COAL SYSTEMS, Inc.

These quick sketches show the modified sediment pond design. As can be seen, the pond is no longer totally incised. It has been raised 3 feet and made only 5 feet deep. The area of disturbance is as before. As can be seen from the stage volume curve capacities are as before and meet regulations. Spillway and decant designs are unchanged except in elevation. Dikes will be made of clay material from the pond bottom and typical sections have been sketched with this submittal. The Pad area has been locally cut down to increase pond volume but the pad has not been raised or otherwise changed. The new permit submittal and as built drawings will reflect these changes. Please let me know if we can proceed with this minor design change.

Stage Volume - Wellington Sedpond

Date October 19, 1989
Fax To Rick Summers and Randy Harden
Company DOGM
Fax # 359-3940
Phone # _____
No. Pages (Including Cover Sheet) 5
FAX FROM Bradley C. Paul
SUBJECT Sediment pond changes
JOB # _____

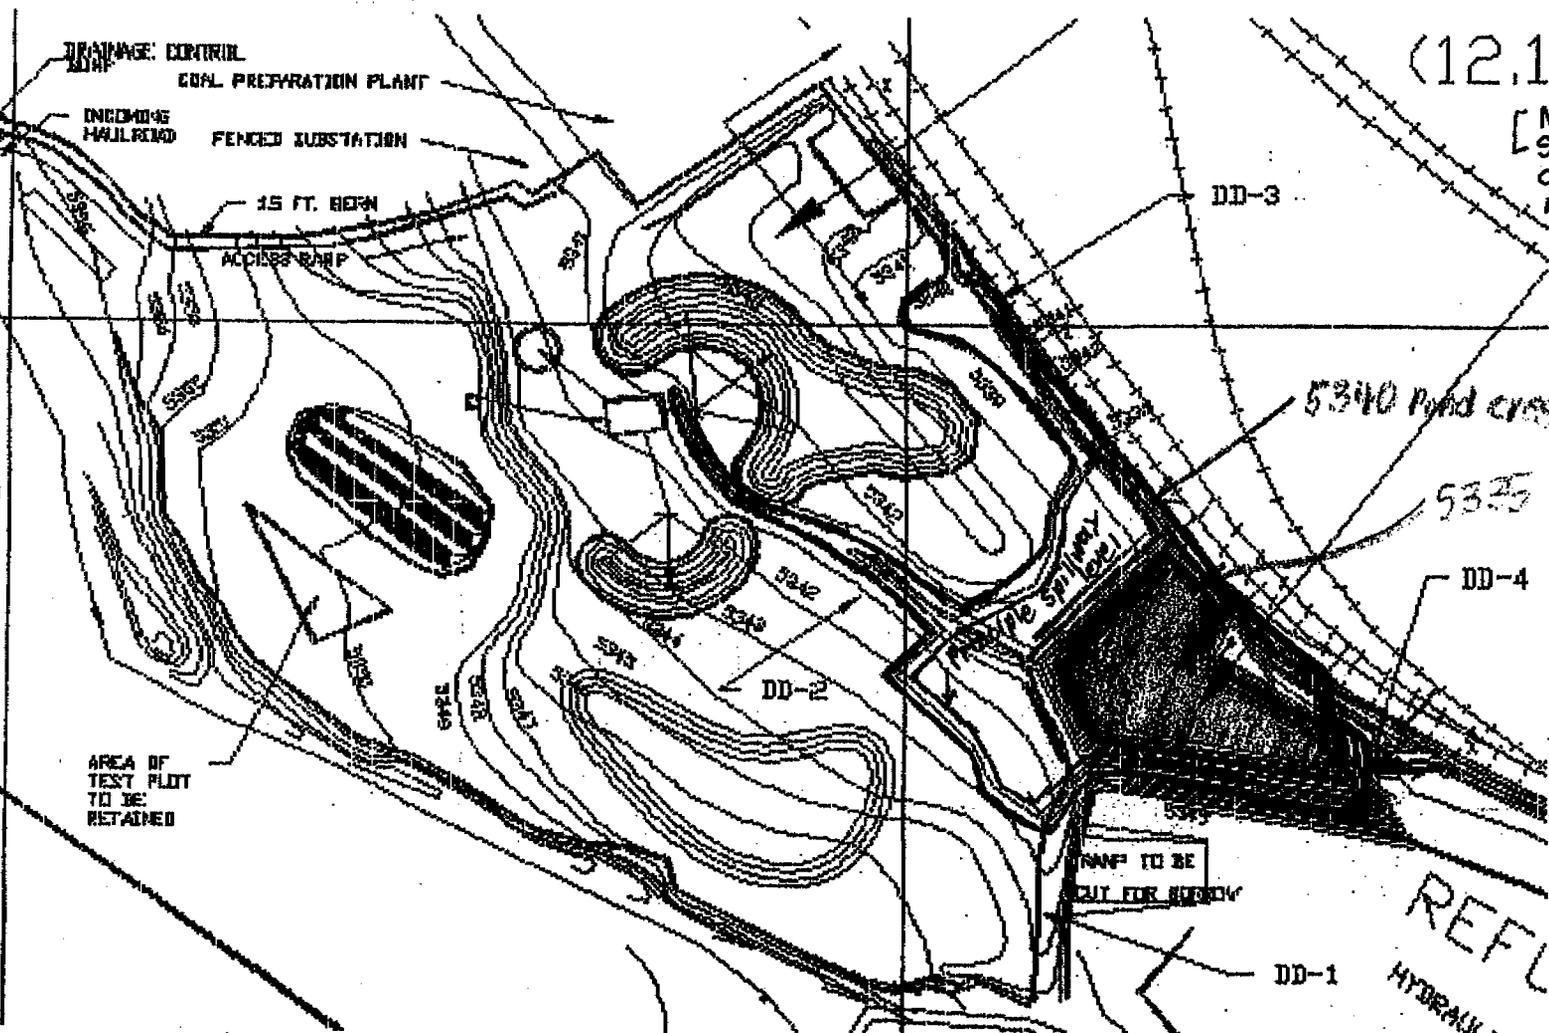
[Note that new contours are super-imposed on old contours to show extent of modification.]

↑ Main Sediment Pond Dike

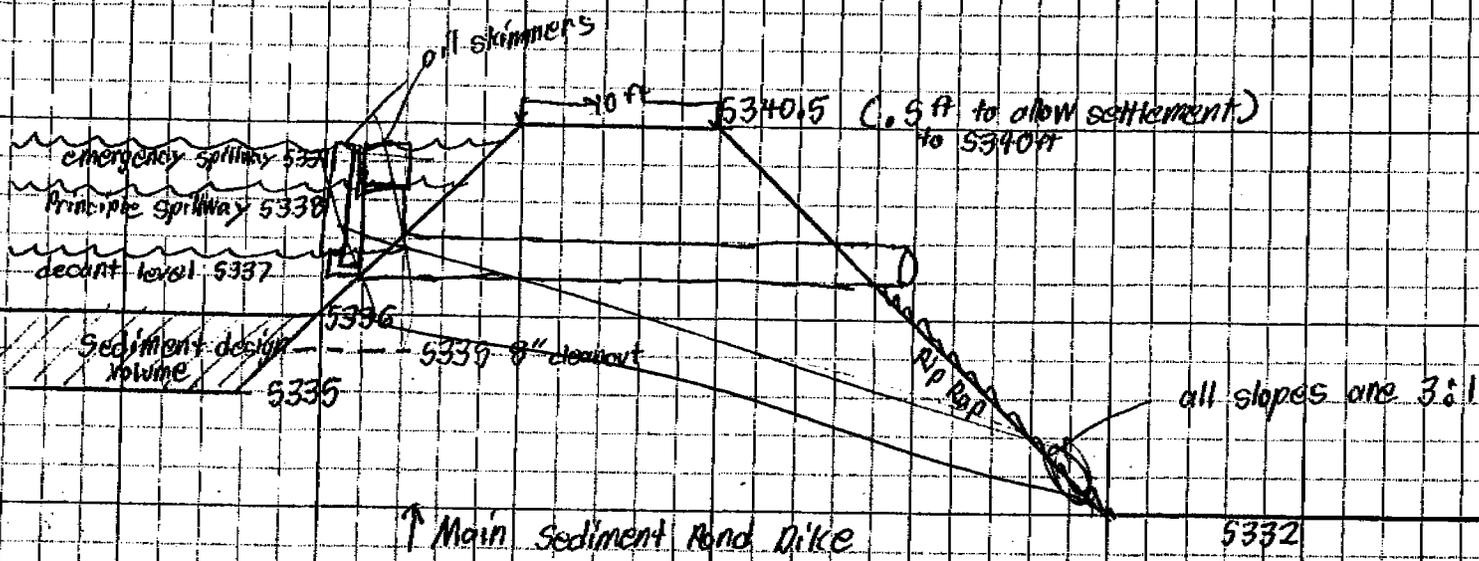
Spillway design as before only elevations differ

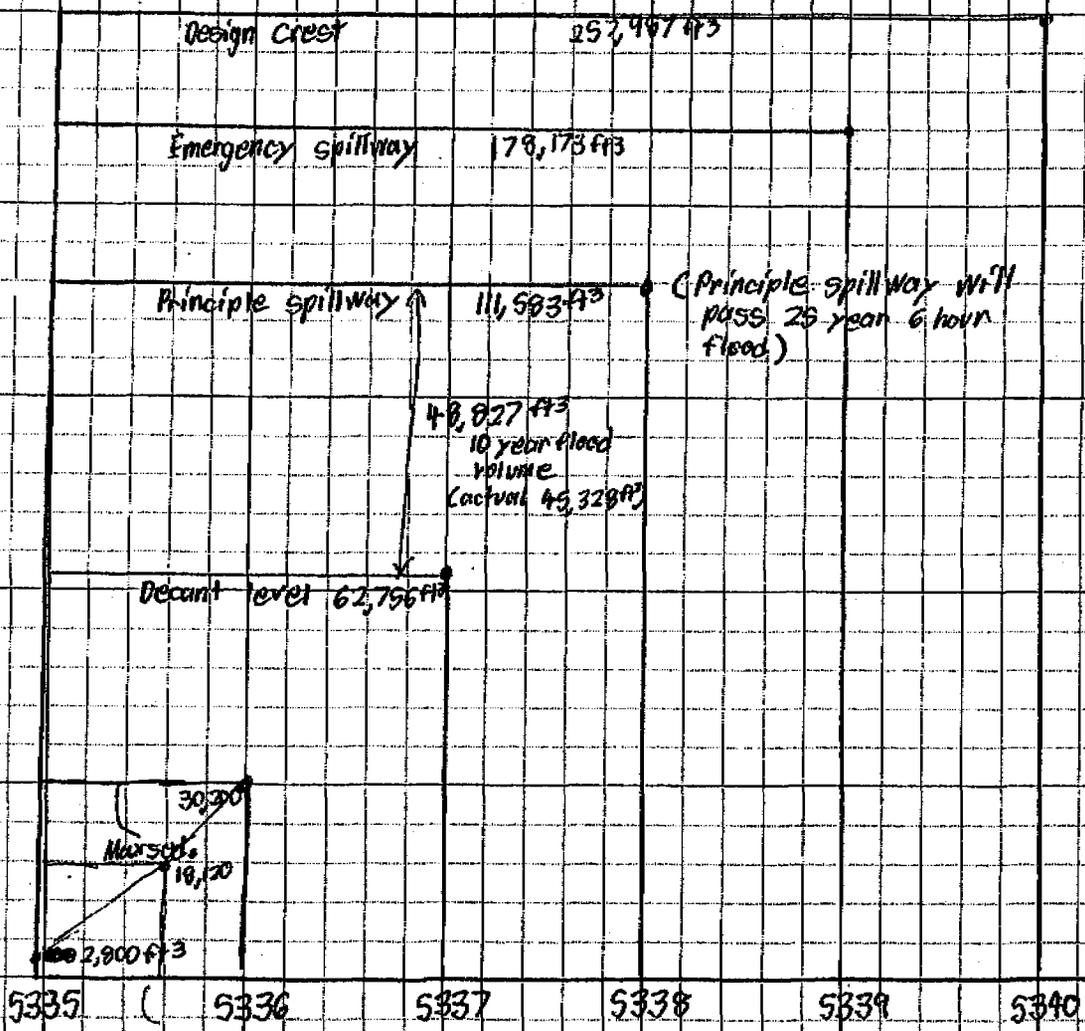
(Principle spillway will pass 25 year 6 hour flood.)

48,827 ft³
10 year flood volume
(Actual 49,329 ft³)

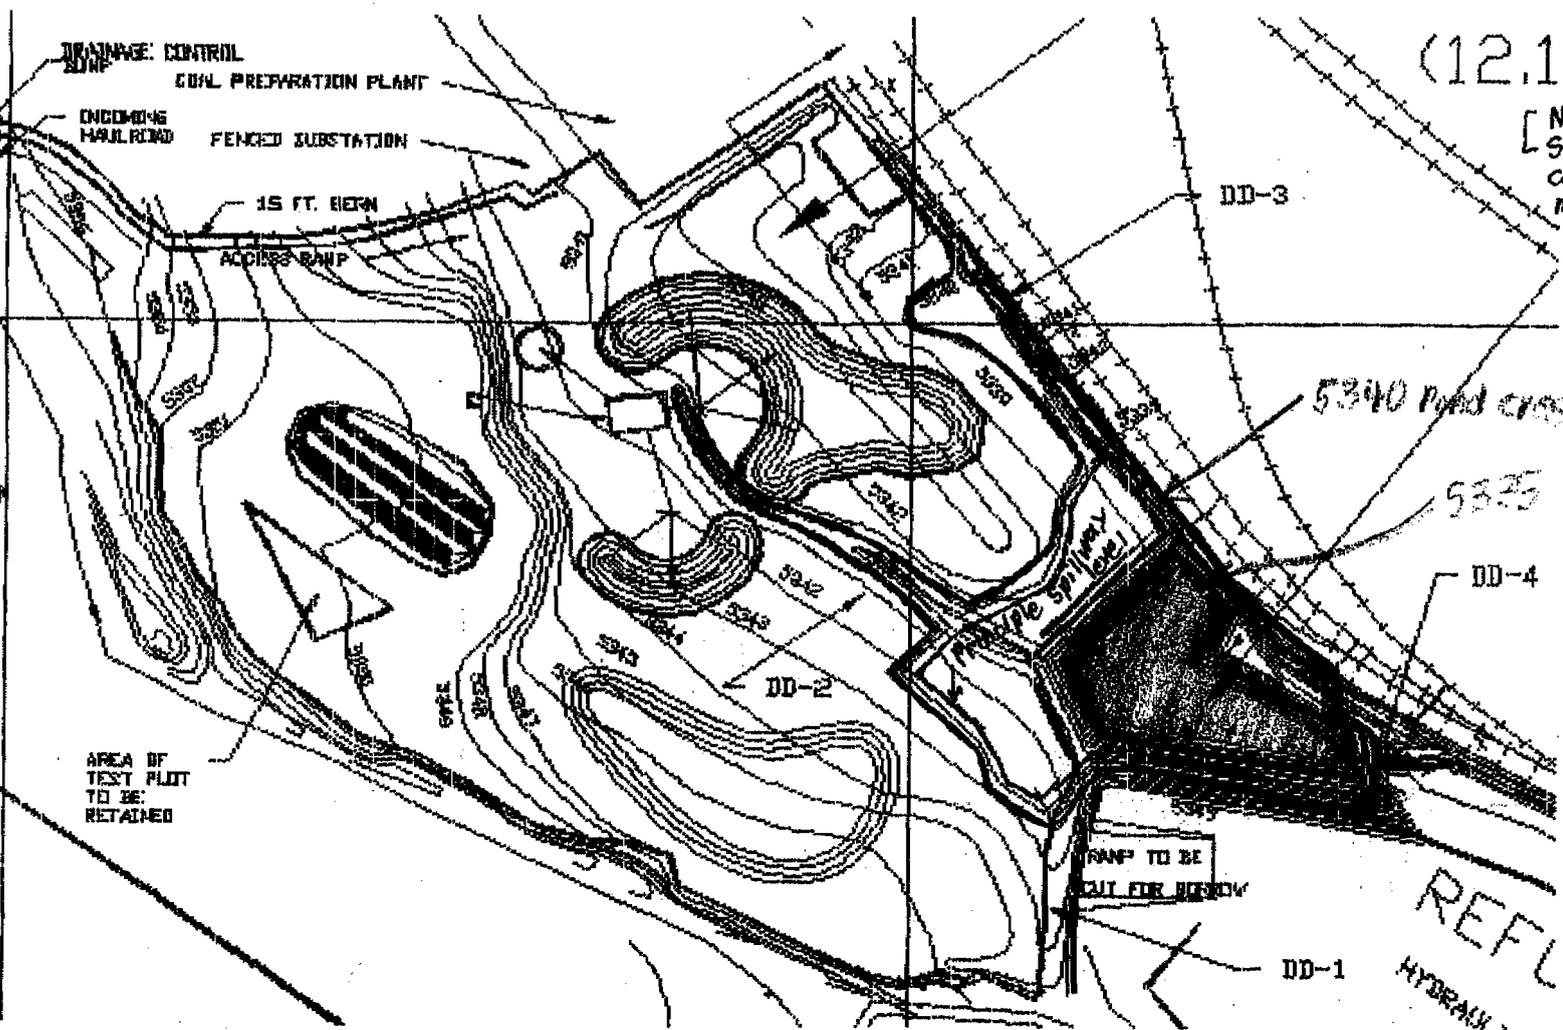
[Note that new contours are super-imposed on old contours to show extent of modification.]

5340 Pond crest

5335 Pond bottom

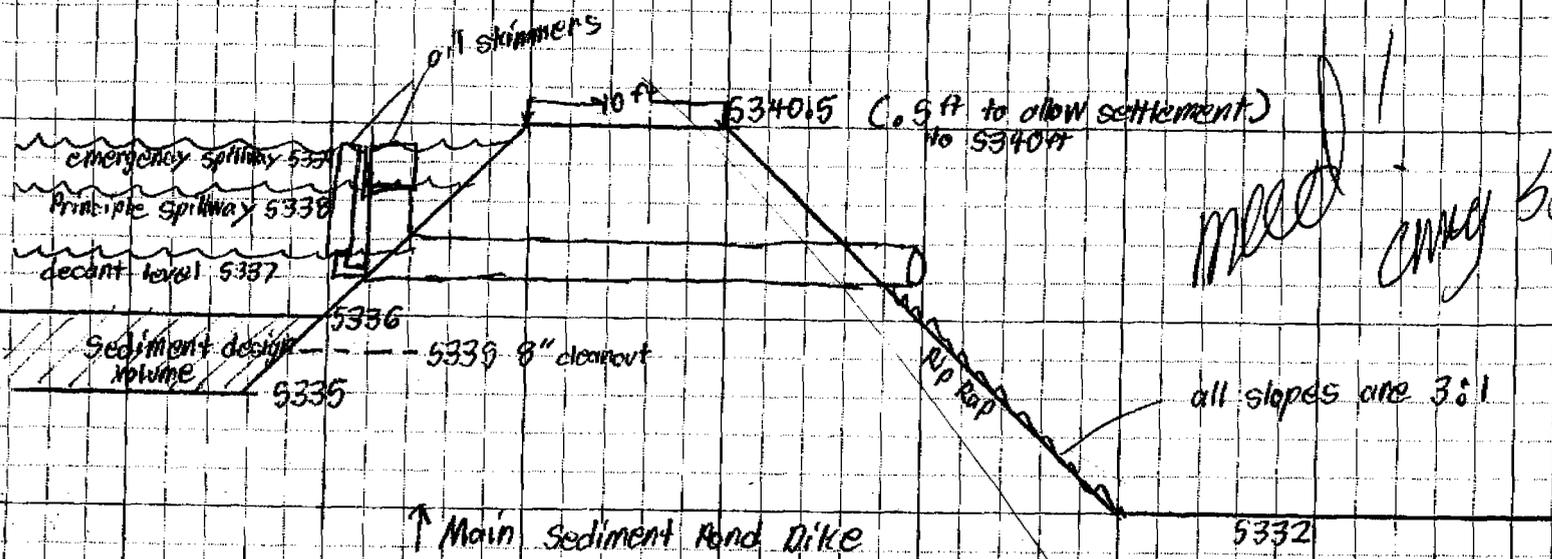
Spillway design as before only elevations differ

need emergency spill design w/ rap to dissipate
